**FINAL REPORT ON**

**GEOTECHNICAL/FOUNDATION INVESTIGATION  
AND DESIGN FOR PROPOSED  
RETAINING WALL ALONG HIGHWAY 63  
W.P. 167-90-00  
MTO DISTRICT 54, SUDBURY**

981-9109

Further to the Technical Review Meeting of January 14, 1999, we provide this second addendum report to provide clarifications to concerns presented. This addendum report must be read with our original reports number 981-9109, dated December, 1998 and number 981-9110, dated August, 1998, along with our first addendum, letter report dated January 5, 1999.

TYPICAL DRAINAGE DETAILS  
W.P. NO. 167-90-00  
HIGHWAY 63

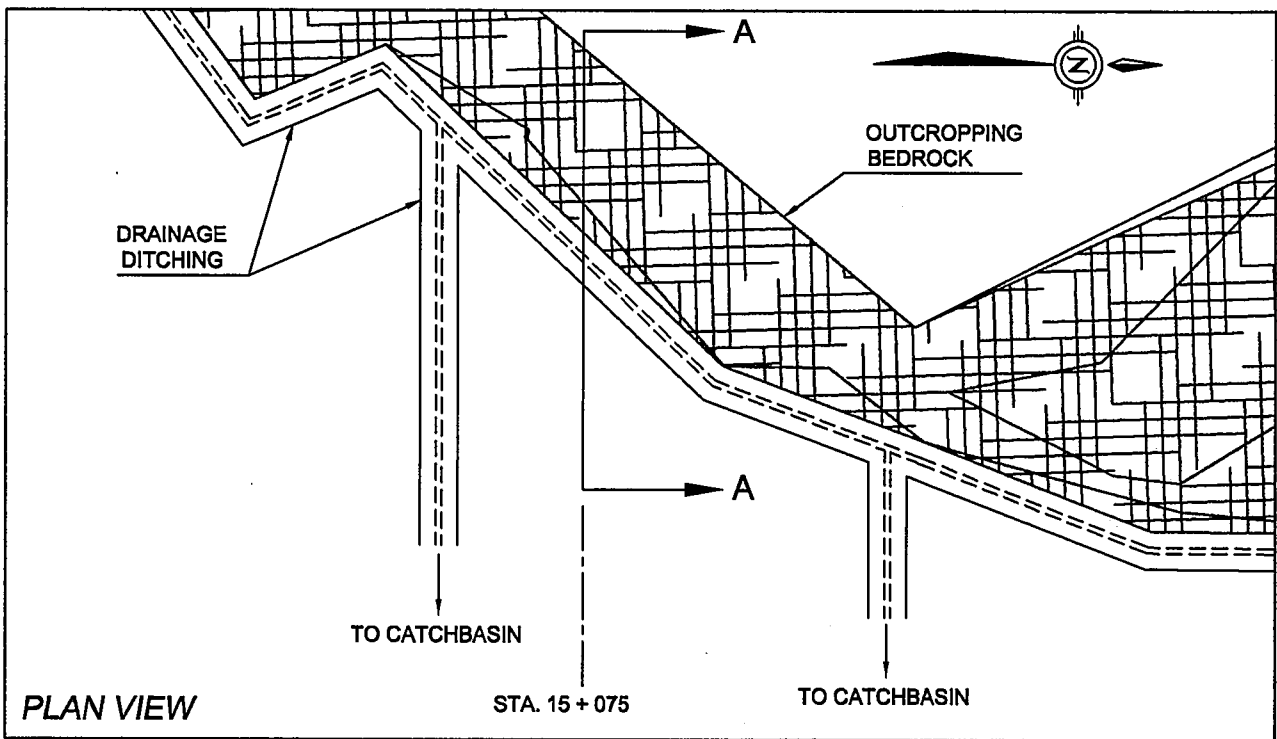
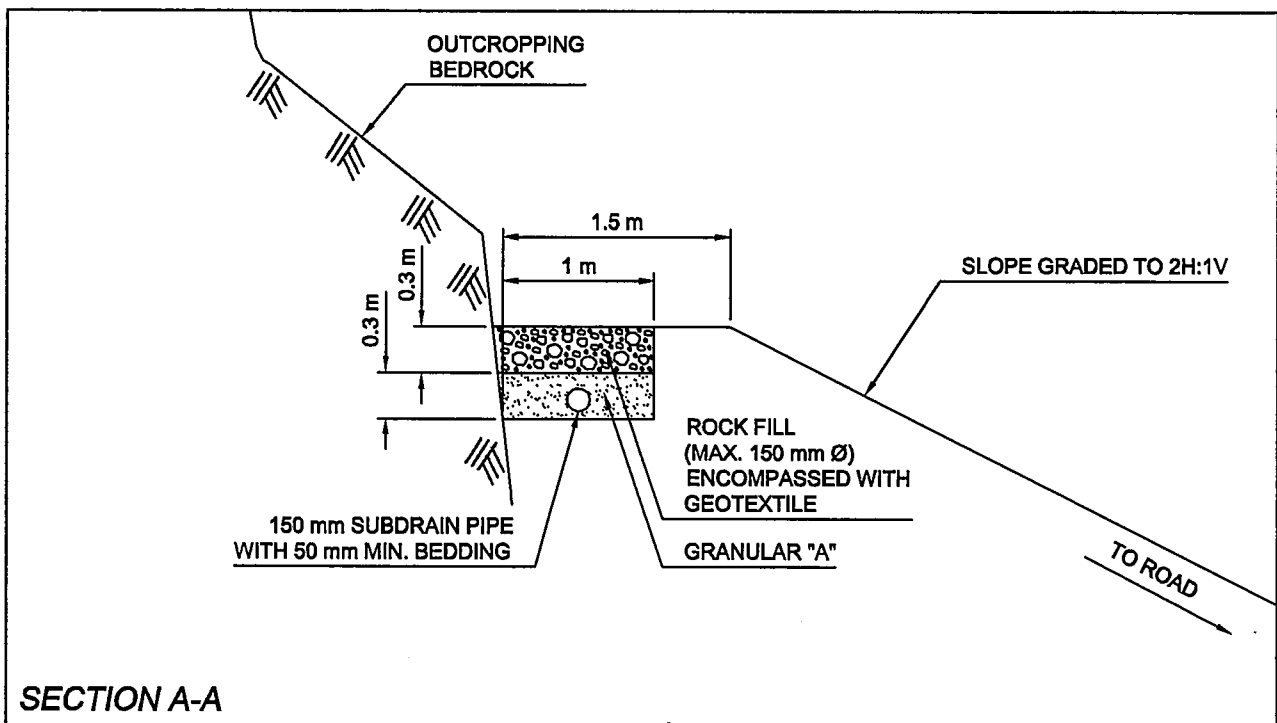
Section 5.3, "Permanent Cut Slopes" of our report number 981-9109 discusses erosion control at the interface of exposed bedrock and the 2H:1V soil slopes. The original recommendation in our report (as shown on Figure 28) included the use of rock filled interceptor drains leading to catchbasins at the base of the slope. Proctor & Redfern has stated that an interceptor drain system would not be practical due to the proximity and anticipated slope of the bedrock surface, along with the variable thicknesses of overburden. As such, the use of such a system has been abandoned. Protection of the native soils from scouring due to surface water run-off from the exposed bedrock using erosion control blanks will most likely not suffice at the soil bedrock interface.
